AIRWORTHINESS DIRECTIVE

No. 2019-FATA-01020A-05

Applicability - RRJ-95 aircraft

on maintaining of airworthiness of RRJ-95 aircraft due to detection of a crack of slat hinge plate

Fig.1 (For illustrative example is shown slat section 4)

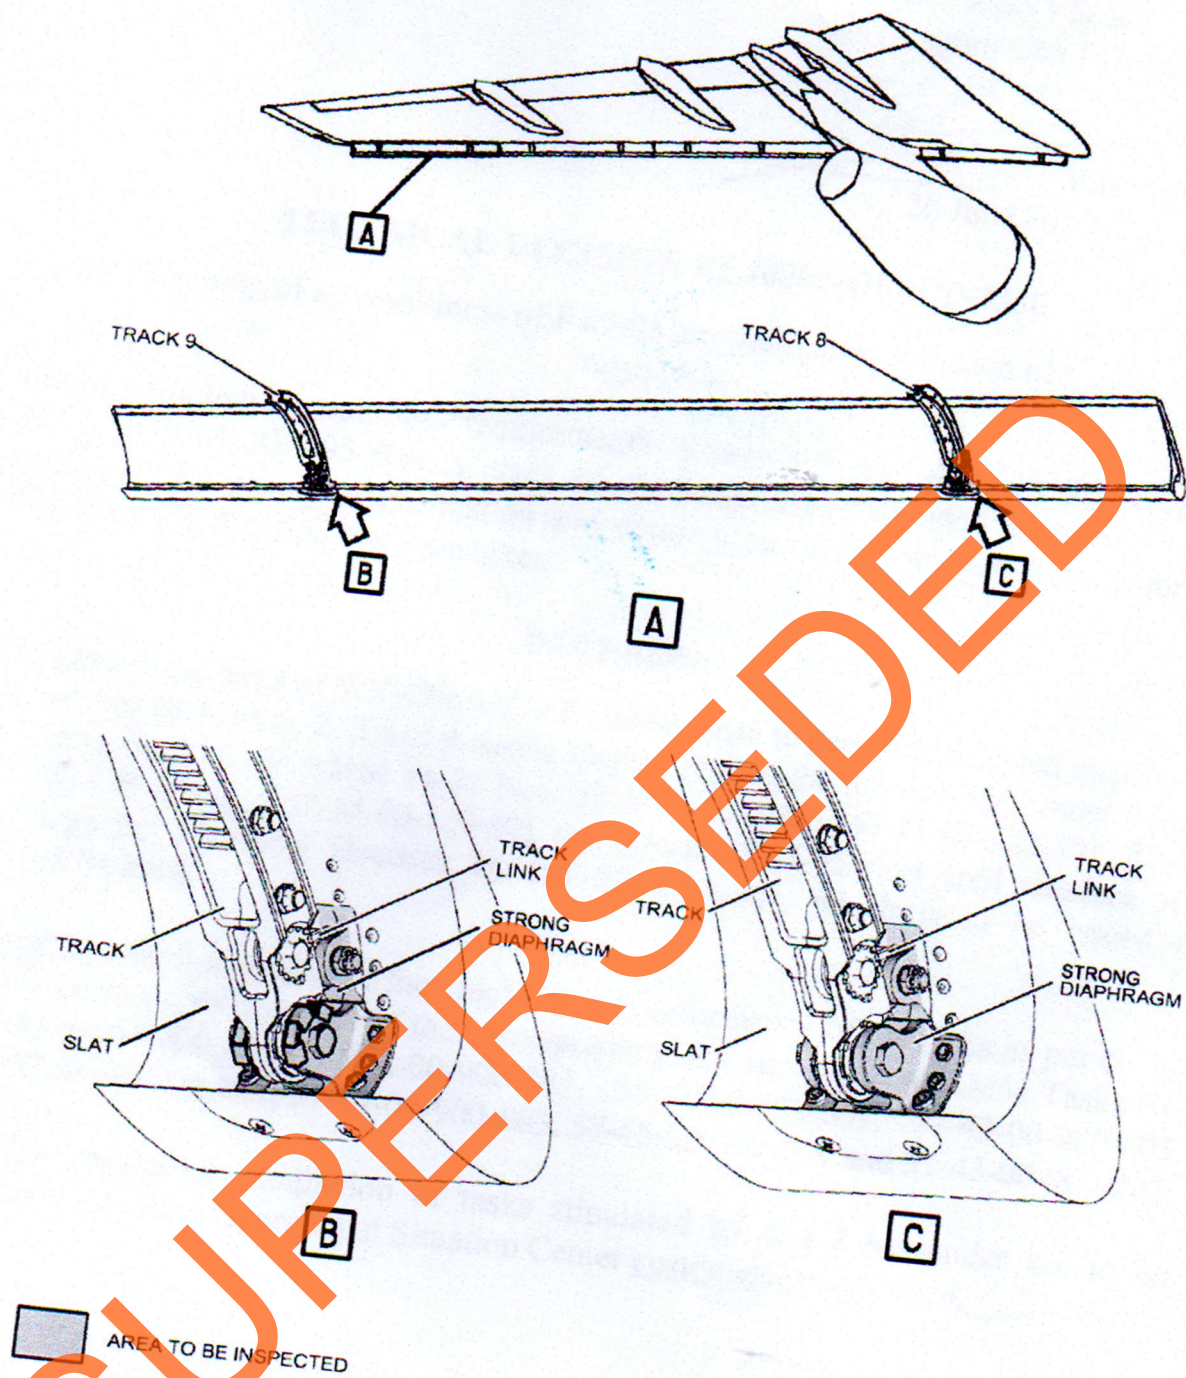
1. On weekly basis of WY-Check/8 DY maintenance to perform "Detailed inspections of slat sections 1, 2, 3 and 4 strong diaphragms on the left and right outer wings" (See Fig.1) IAW AMM Tasks Nos. 57-42-00-220-801, 57-43-00-220-801, 57-44-00-220-801 and 57-45-00-220-801 on operated RRJ-95 fleet until issuance of a separate Technical Decision by the Manufacturer, which is to be issued on 15.08.2019.
2. In case of a detection of the crack during performance of the tasks as per cl. 1 – to perform replacement of the corresponding slat section IAW AMM Tasks No. 57-42-00-900-801, 57-42-00-900-803, 57-43-00-900-801, 57-43-00-900-803, 57-44-00-900-801, 57-44-00-900-803, 57-45-00-900-801 and 57-45-00-900-803.
3. The results of completion of tasks stipulated by cl.1-2 hereunder are to be reported to the Operational Situation Center customercare@scac.ru.
